B&NES Core Strategy

Hignett Family Trust Ref: 276

Addendum 2 to PS

**Review of WYG Engineering Bath Compensatory Storage Study Phase 1
– Final Report dated November 2011 (CD4/FR35)**

Figure 1 - Direct or “level for level” Flood Plain Compensatory Storage

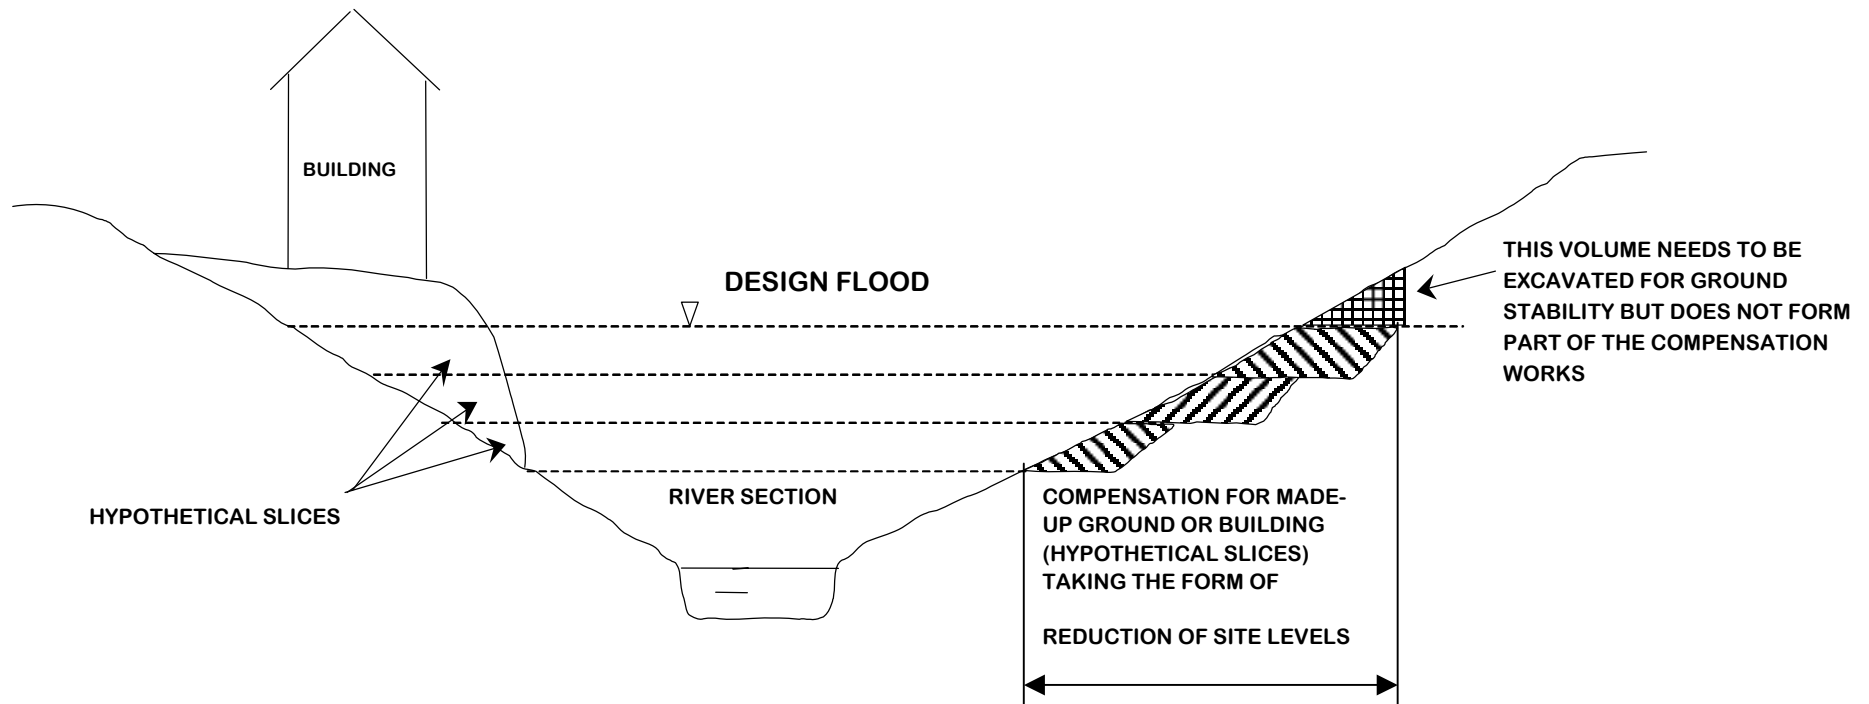
Any loss of flood storage must be compensated for by the reduction in level of nearby ground, such that the same volume is available at every flood level before and after the works and it can freely fill and drain. In other words, in order to mirror the existing situation for a particular flood, each stage (or level) is provided with the same storage volume, cut and fill must equate on a level for level basis, ie at each level (say at 0.2 metre vertical intervals for example) the excavated and filled volumes are equal.

The timing at which the storage effect comes into operation is significant. If this volume is reduced for any stage of a flood then the lost storage results in flood waters being diverted elsewhere, leading to third party detriment. The detriment caused by a small encroachment may not be significant, or even measurable, when taken in isolation but the cumulative effect of many such encroachments along a length of river will be significant.

It is not adequate compensation to provide indirect compensation storage by means of :

- *excavating holes in the existing floodplain as these fill early in any flood event.*
- *provide low level compensation volumes to replace high level floodplain and vice-versa as the river flows do not necessarily fill these compensation areas at the same time as the development site would have filled prior to being raised.*

09213-SK3A - Kensington Meadows Flood Compensation Storage Area - Typical Sections

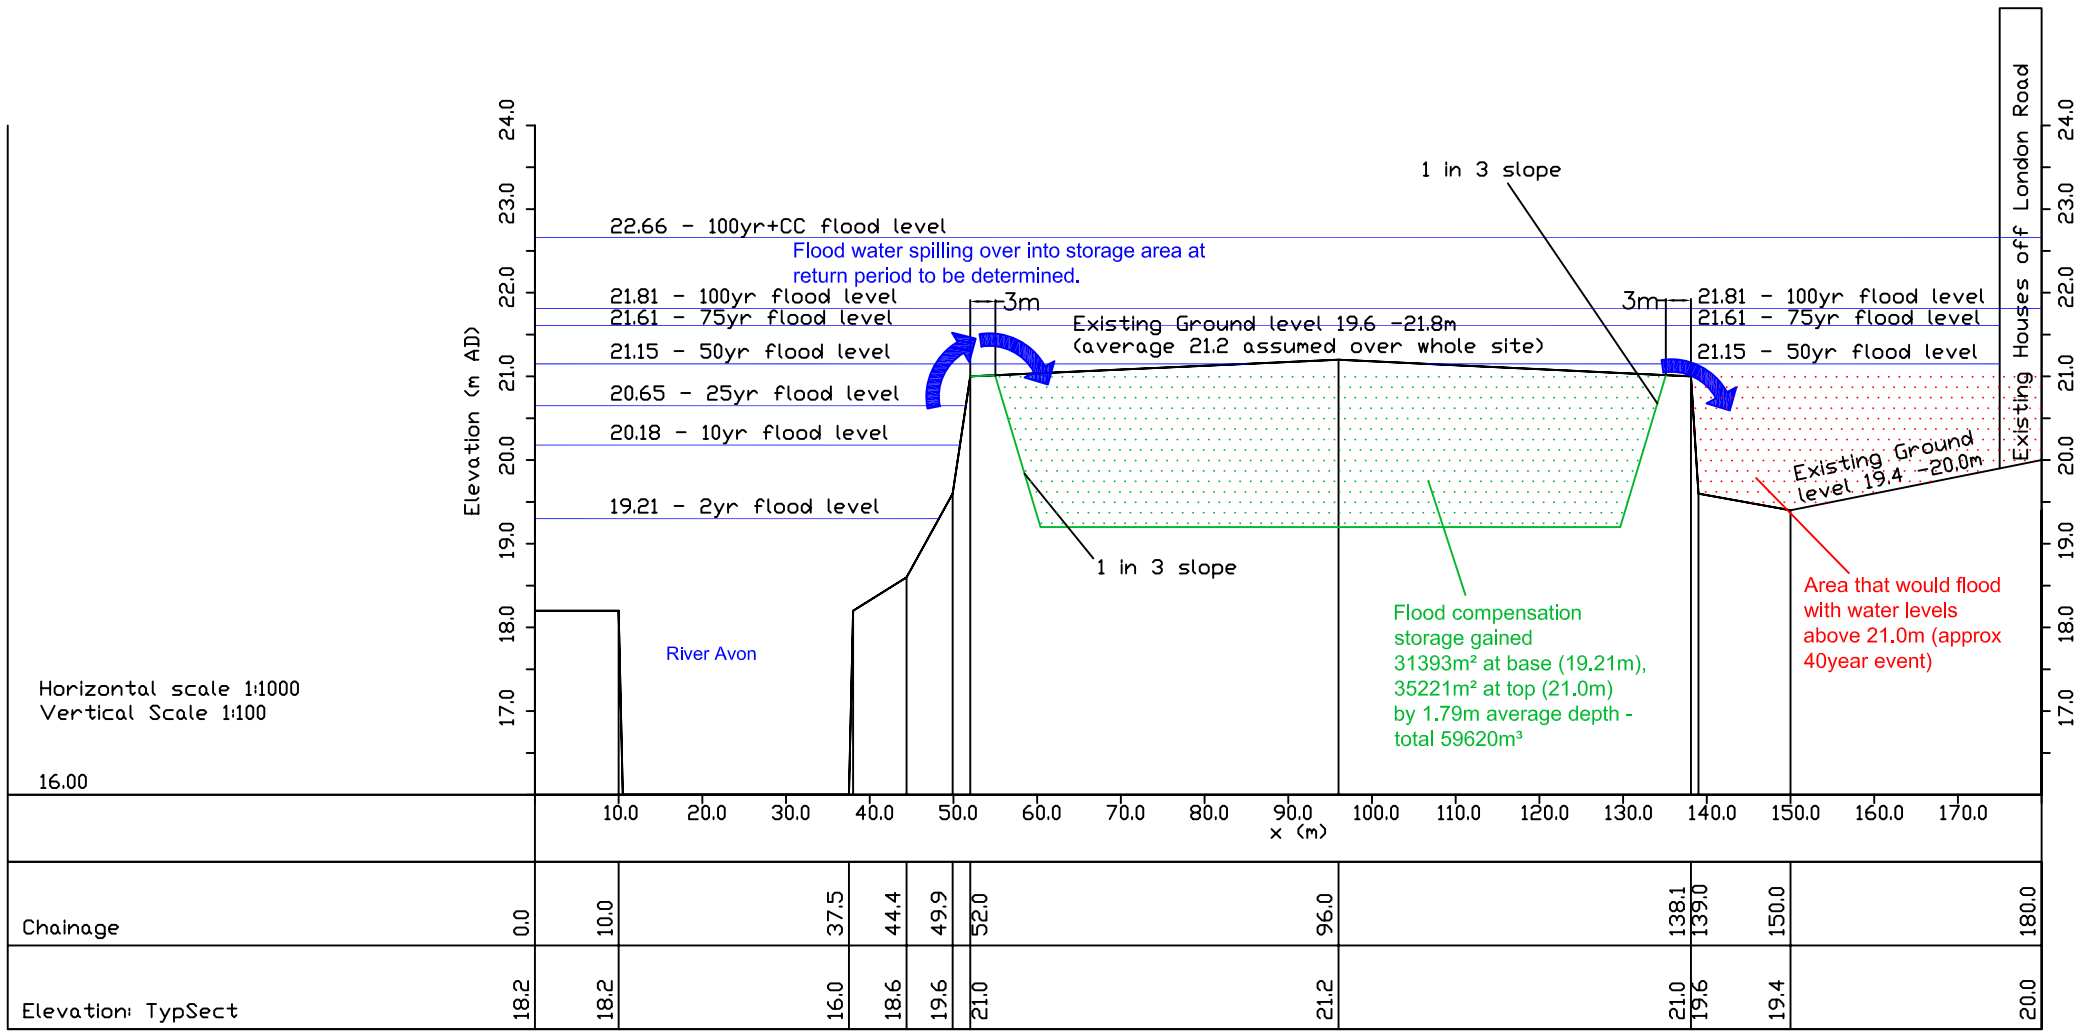
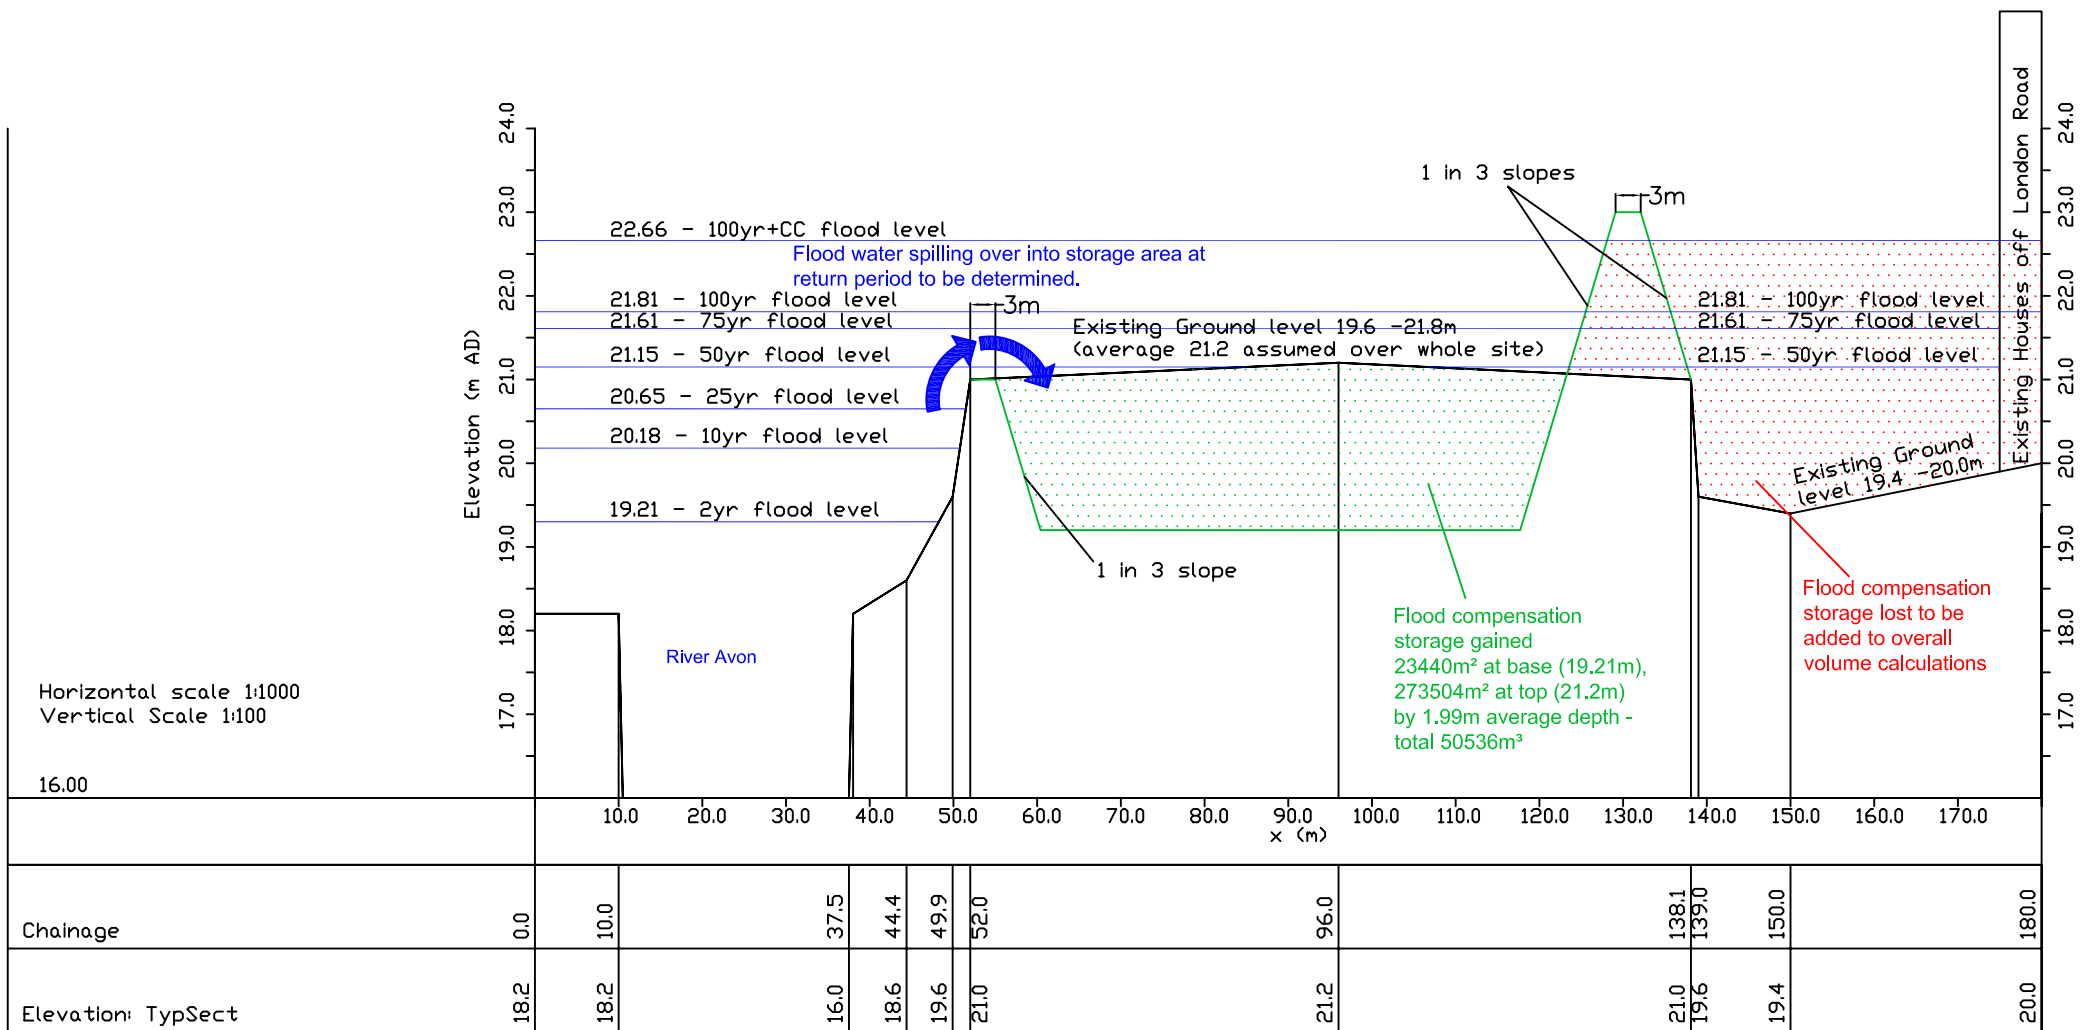
This site lends itself to retaining the higher frontage level of 19.6 – 21.0m and excavating behind to create a controlled filling of the created void. The front bank (weir) controlling the flows into the storage will need to be 2 - 3m crest top width to maintain the structural integrity against the head of water on the Avon side with 1 in 3 side slopes as WYG have suggested.

The 2 year flood level is 19.21m, the 10 year is 20.18m, the 25 year is 20.65m, the 50 year is 21.15m and the 75 year flood level is 21.61m. Water would pass over Kensington Meadows at approximately 21.2m affecting property to the north as the land and housing to the north of Kensington Meadows, in London Road and Ringswell Gardens, is lower than Kensington Meadows itself and is also located in Flood Zone 3. The lowering of any frontage of Kensington Meadows to the Avon or the excavation of a new flood storage area would create an increased flood risk to any properties in that area. Without providing any enhanced defence to the properties to the north, the maximum compensatory storage level of Kensington Meadows is therefore approximately 21.0m, where existing site levels would retain any flood water from inundating existing

properties. An alternative would be to raise an earth embankment on the northwest boundary to a higher level, to create more storage at Kensington Meadows, but the volume of flood plain lost to the north and the embankment volume itself would need to be taken into account, in any detailed cut / fill flood compensation design.

Excavating to 19.21m and with water filling to 21.0m, we calculate that up to 59,620m³ flood compensation storage could be provided, however this volume makes no allowances for the sterilised area mentioned by WYG, where an existing public sewer runs across the site.

If water was stored to a higher level of 21.2m with raised defences on the northwest area of the site, then the volume of potential storage would drop to 50,536m³ excluding any allowances for the loss of floodplain in Ringswell Gardens and London Road.

It can therefore be seen that flood compensation storage is only available between the 2 Year and 50 Year storms, after that the Kensington Meadows site is under water during the existing flood regime. If measures are taken to protect properties put at risk, to the north then the site will have a net compensatory storage of less than 14,500m³ as the area in Flood Zone 3 to the north is over 2.6ha with water levels up to 2.2m deep adjacent to Kensington Meadows.

Drawings 9213-SK3 and SK4 included in Appendix 1 show the typical sections of the two options at Kensington Meadows.
